Marine Management Organisation

Planning Act 2008, Proposed North Falls Offshore Wind Farm Project Order Deadline 7 Submission

This document comprises the MMO's submission for Deadline 7.

Figure 1. Five Estuaries ECC (TH019) disposal site in yellow bounded by a light blue highlight, and the proposed North Falls Offshore Windfarm disposal site area is yellow.

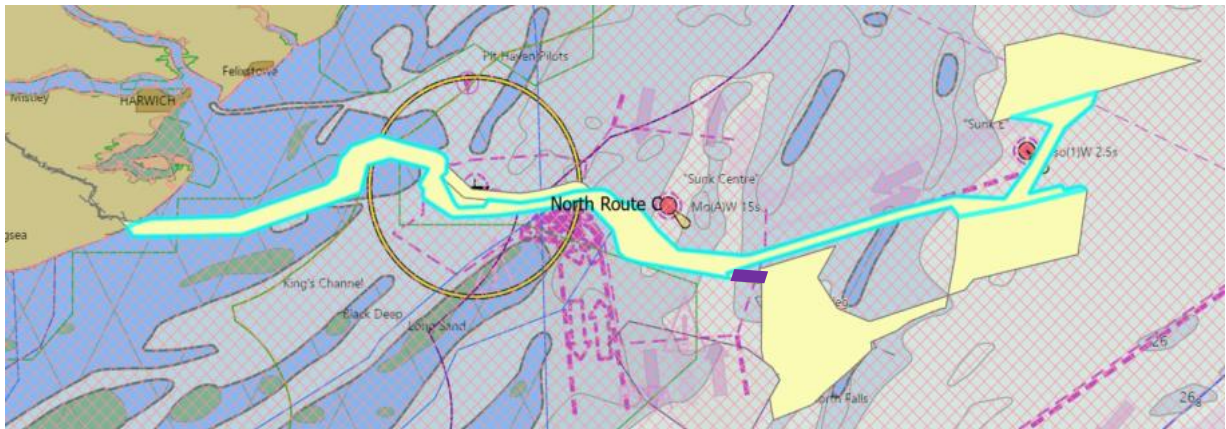
9.2.2 A revised disposal site has been prepared for the Five Estuaries Export Cable Corridor (ECC) (TH019) disposal site to include the ECC for North Falls. The MMO has requested a new disposal site for the array area.

9.2.3 In Figure 2 the area in the middle of the ECC shows an unhighlighted yellow area that is to be included in the Five Estuaries (TH019) disposal site for use with either construction project. The MMO notes that the section in Purple was not included in the shape file for the ECC and therefore has not been included. The MMO will continue discussions on if this area should be included in the ECC or the Array area.

9.2.4 The new area for a combined disposal site overlaps DCO/2019/00008 Five Estuaries Array (TH018) and Cable Corridor (TH019) but not entirely, as well as the array area for Galloper OWF (TH057) in the North – dark areas not highlighted in pale blue (Figure 2).

9.2.5 The MMO is currently designating the updated Five Estuaries ECC (TH019) area. The yellow area in for the Array area is also being designated as we would expect a new area to be included for the array (bottom yellow area under the ECC).

9.2.7 The MMO requests that the following is updated to the DML so that confirmation of designation and use of these sites can be confirmed by the MMO, due to the timescales this won't be provided prior to the end of Examination but the MMO will provide this to the Applicant via email as soon as possible.
